Public Works Standard Drawings Subcommittee Meeting

Monday, March 16, 2020

Division 2000: Pavement Systems

2010

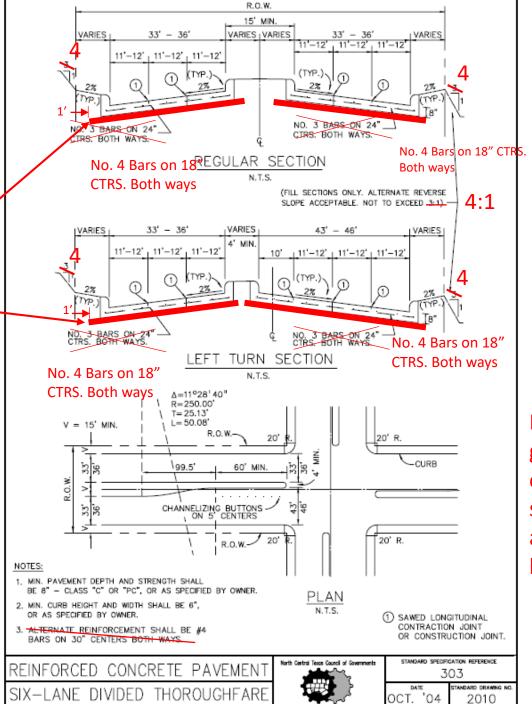
Replace Plan with a more general layout to include crosswalks, ADA ramps, striping, and possibly additional lane width for bicycle lanes per TxDOT

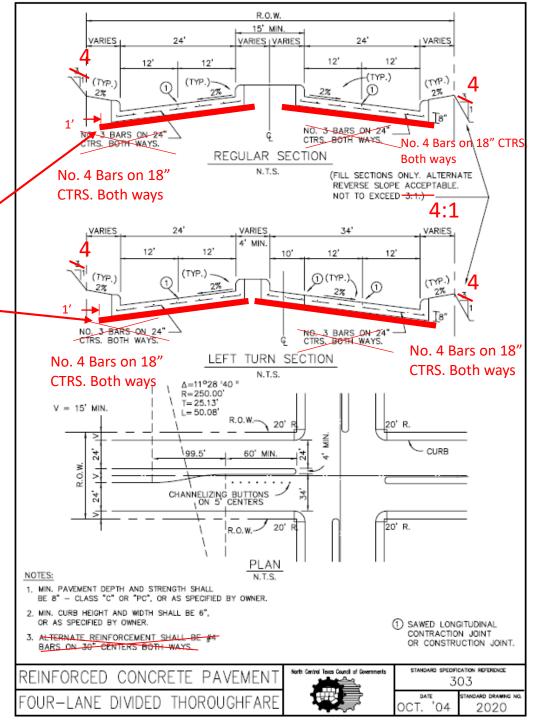
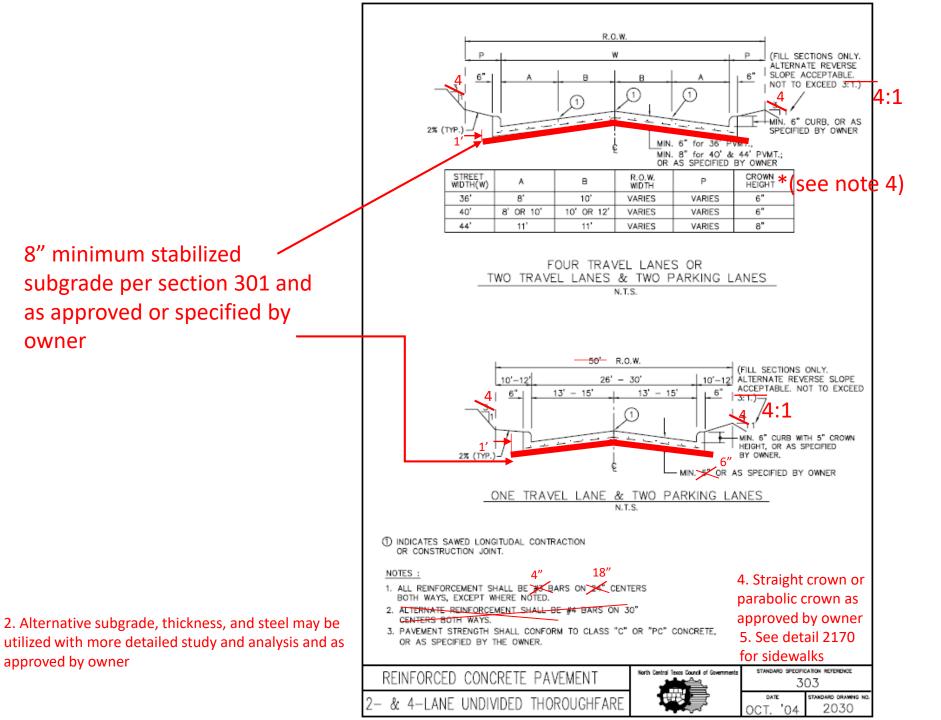
Replace Plan with a more general layout to include crosswalks, ADA ramps, striping, and possibly additional lane width for bicycle lanes per TxDOT

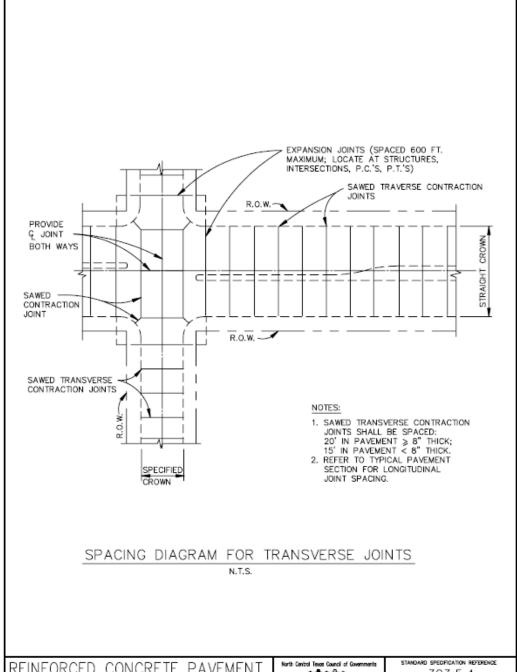
*cleanup lines through median

TANDARD DRAWING NO. 2060

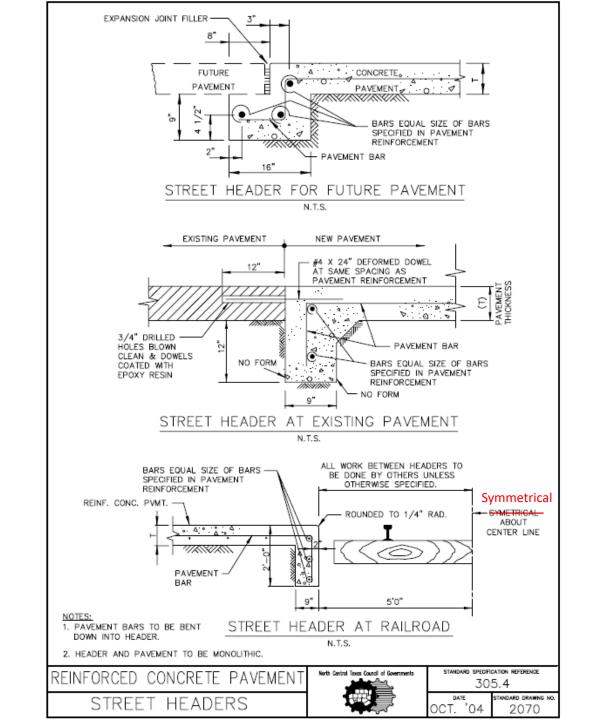
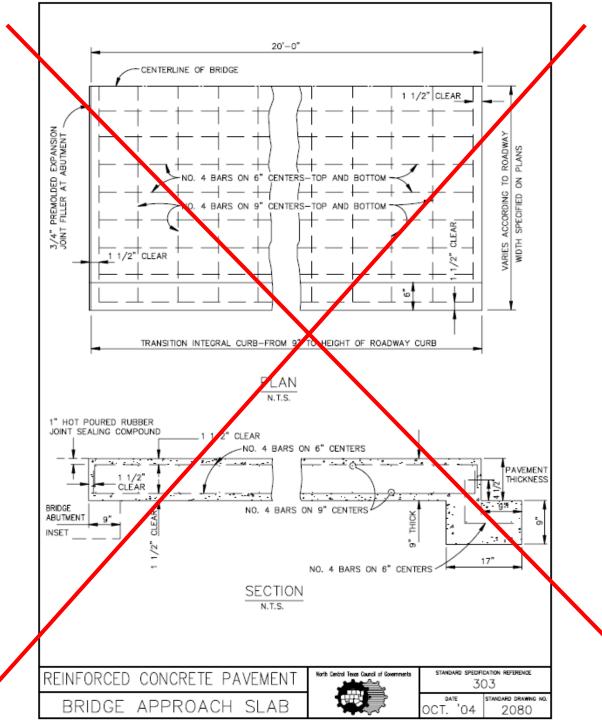
Remove detail and reference TxDoT detail in specs if needed
